UNITED STATES PATENT AND TRADEMARK OFFICE

APPLICATION NO.	FILING DATE	FIRST NAMED INVENTOR	ATTORNEY DOCKET NO.	CONFIRMATION NO.
10/767,599	01/30/2004	Bernardo Ayala	BA01-01U	5201

Office Action Summary

DETAILED ACTION

Note the wiring and light bulb support (see Examiner's annotated Figure 3) are considered part of the frame structure where they are attached to the frame structure.

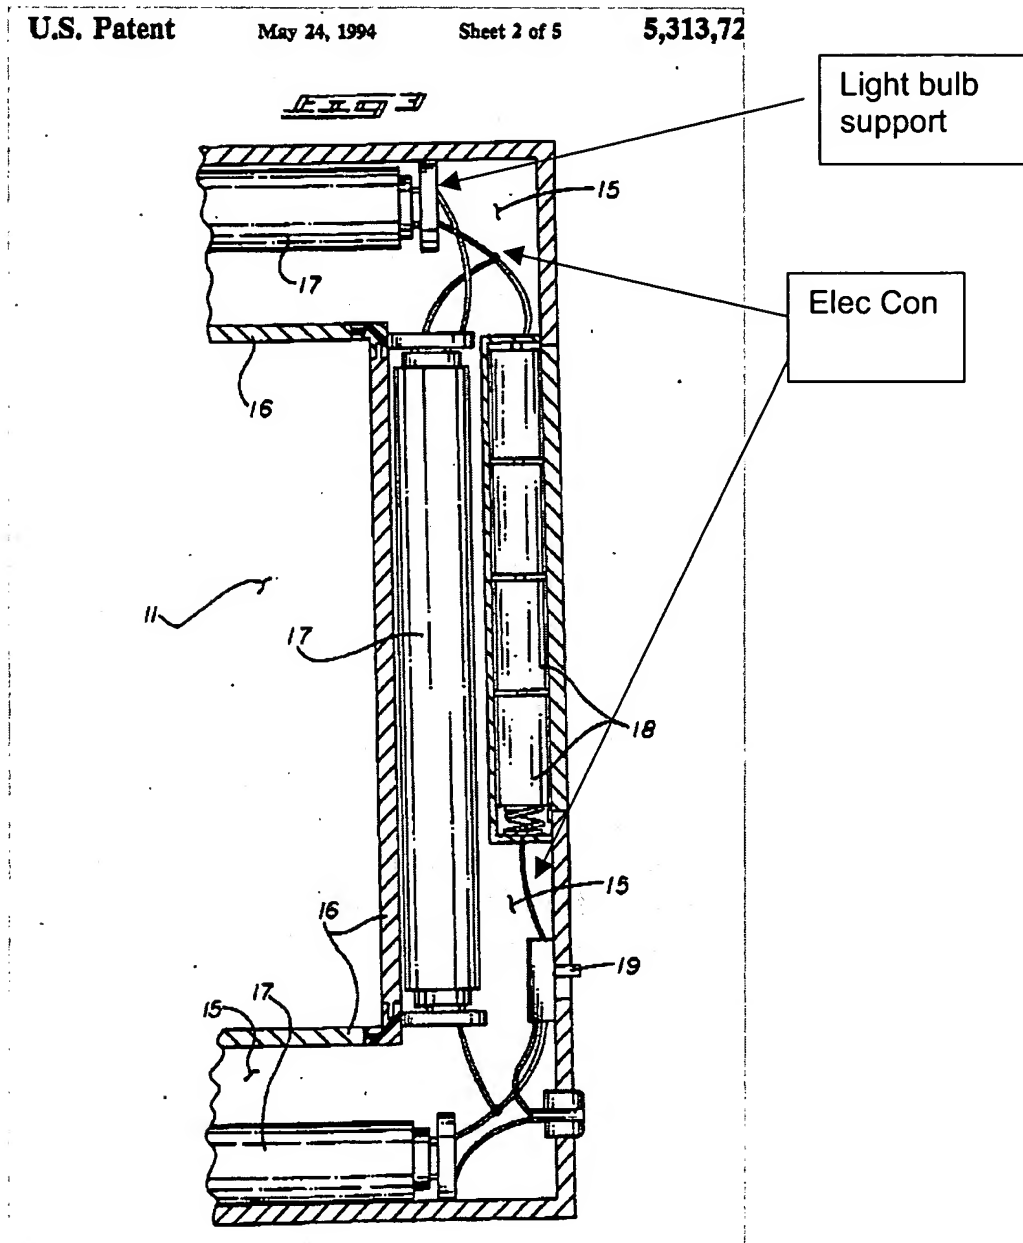
Warner teaches a picture frame with integrated power control and lighting comprising;

a frame structure (12) capable of retaining a replaceable image (11),
at least one power storage device/battery (18) located within the frame structure (12), as well as an external power source (20) located external to the frame structure,
a power control device (19) located within the frame structure (12),
at least one light source (17) located in front of the image located within the frame structure such that light can shine on the front of the image, and
an electrical connection (Elec Con, see Examiner's annotated Figure 3) located within the frame structure as part of the frame structure that connects the power control mechanism/device (19) and the light source (17).

Note, while no image is shown in Warner, Warner clearly teaches the invention is directed to project illumination onto a central picture mounted about the central support (11), see column 1, lines 41-47, where the picture is for viewing.
